**North Harbour 2 Watermain - Earthworks, Erosion and Sediment Generation for Albany Reservoir Option 2**

Project Name: North Harbour 2 Watermain  
Project Number: AE04521

**NORTH HARBOUR No.2 WATERMAIN GENERAL ROUTE PLAN**

**Additional information relating to NH2 and NI Shared Corridor - Options 1 & 2 at Albany Reservoir, Spencer Ridge Reserve and Corinthian Drive**

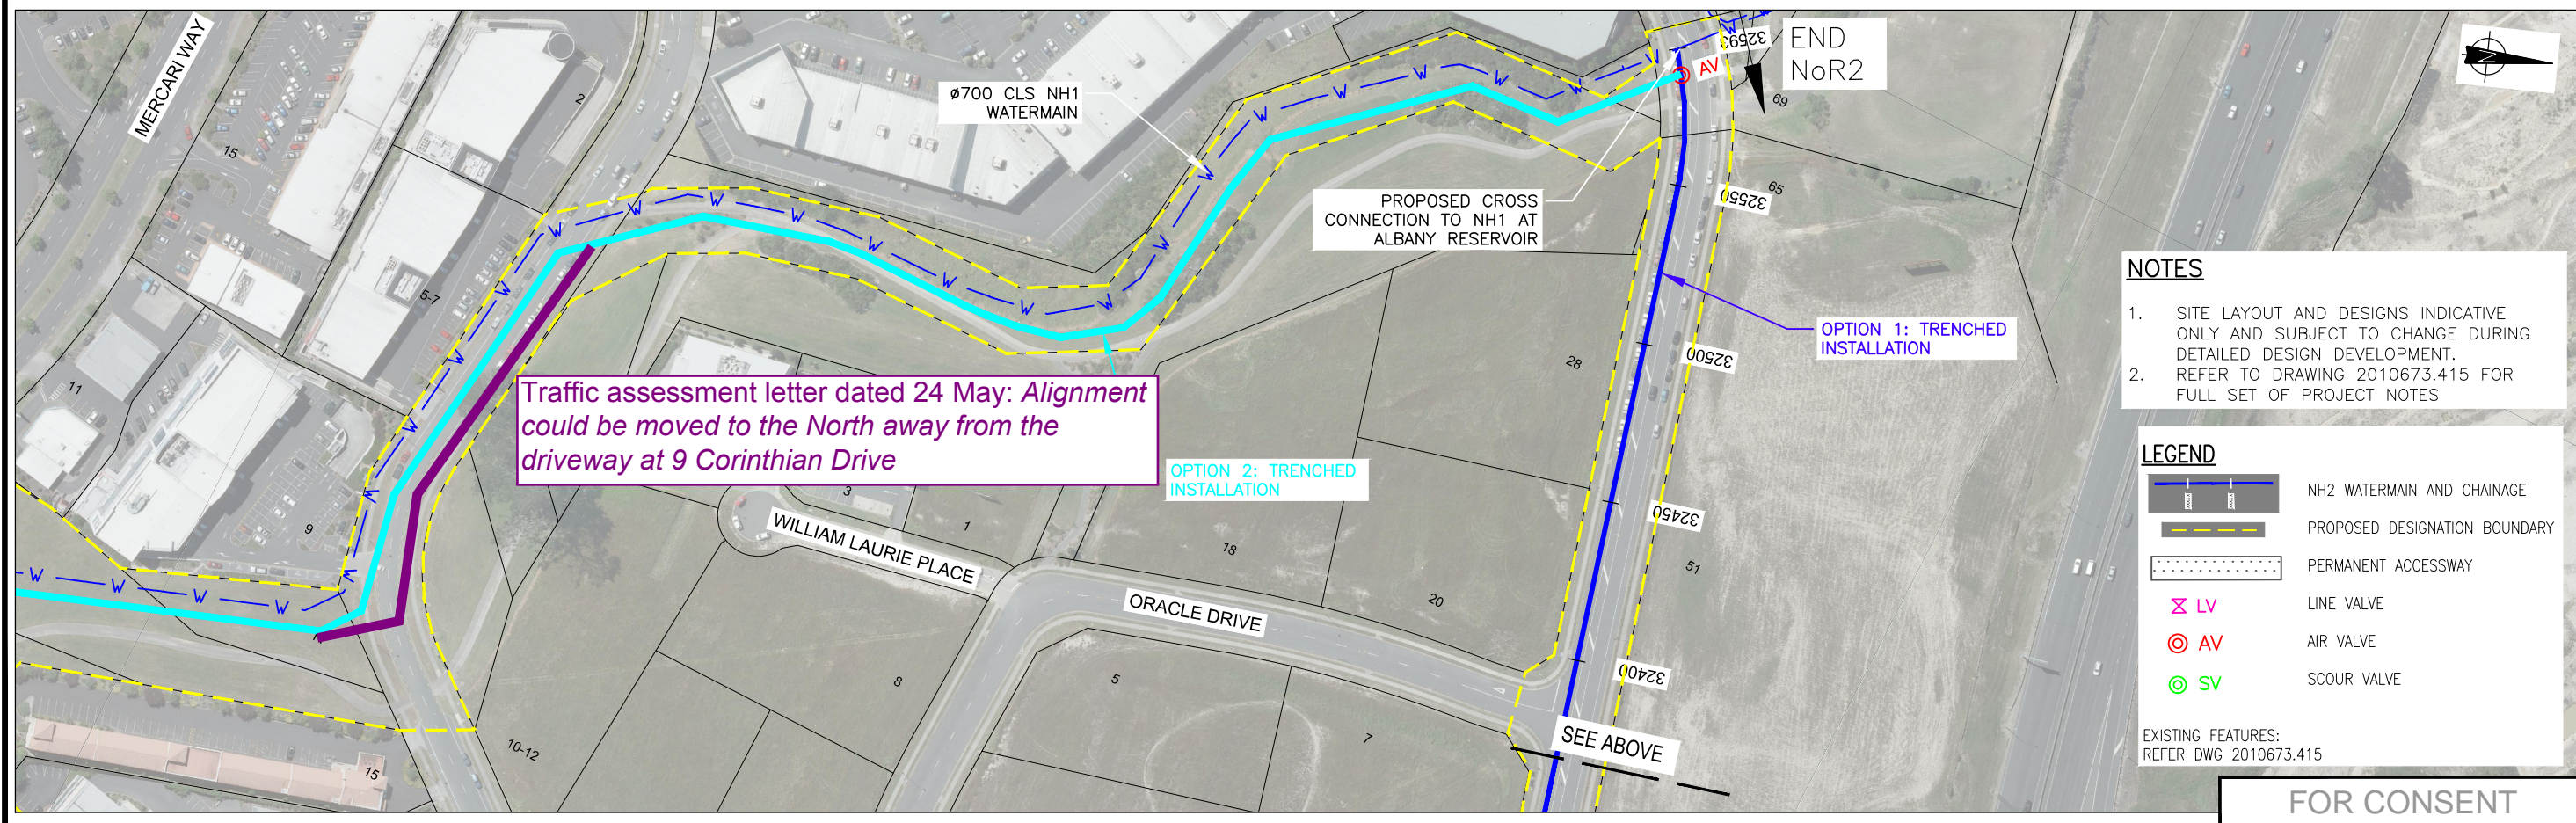
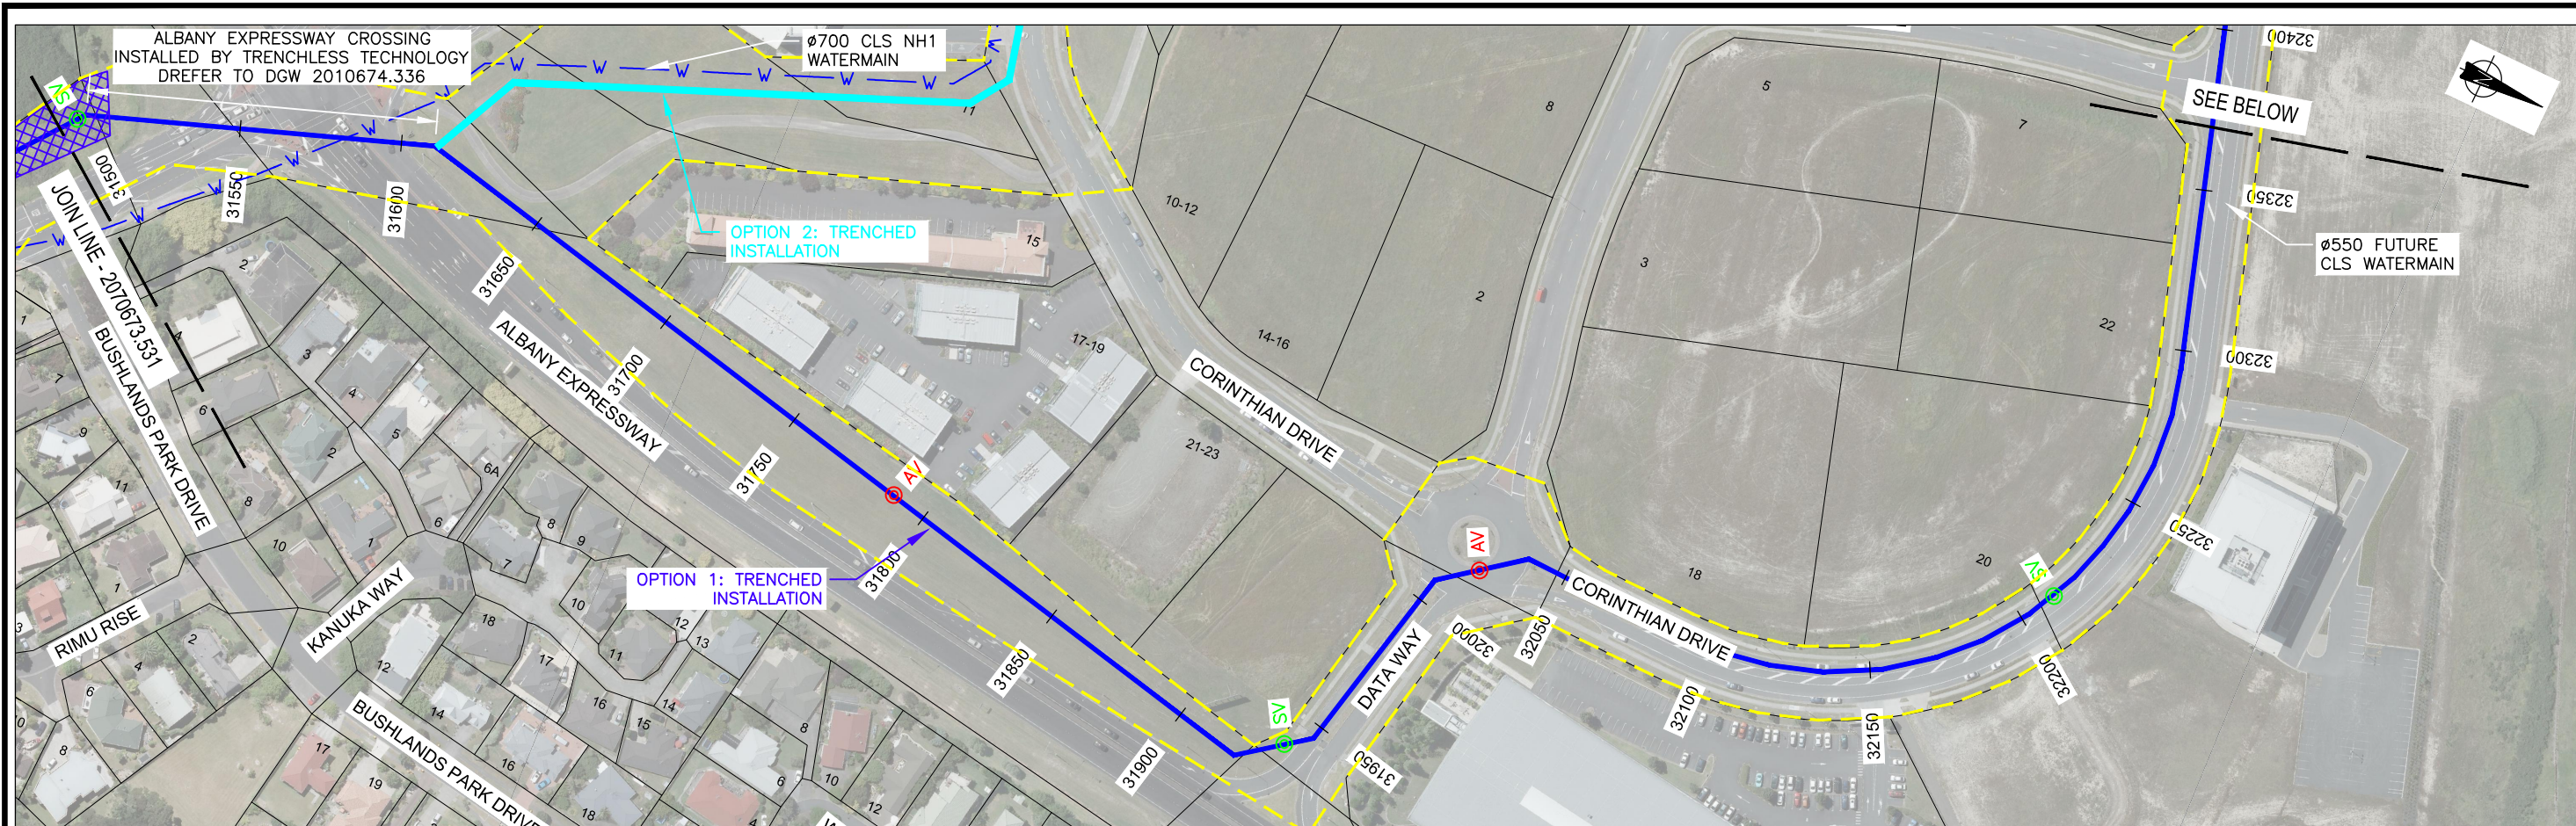
It should be noted that the section of road near 9 Corinthian Drive would likely be restricted to only 1 lane of traffic during construction. The current alignment of Option 2 would block the driveway to 9 Corinthian Drive during construction. To mitigate this effect, one of the following measures is recommended:

1. Option 2 alignment could be moved to the north side of the road as the current alignment would block the driveway during construction (see attached sketch).
2. Complete the construction work in the vicinity of 9 Corinthian Drive during off peak periods (i.e., nights, weekends or holidays) to minimise the impact
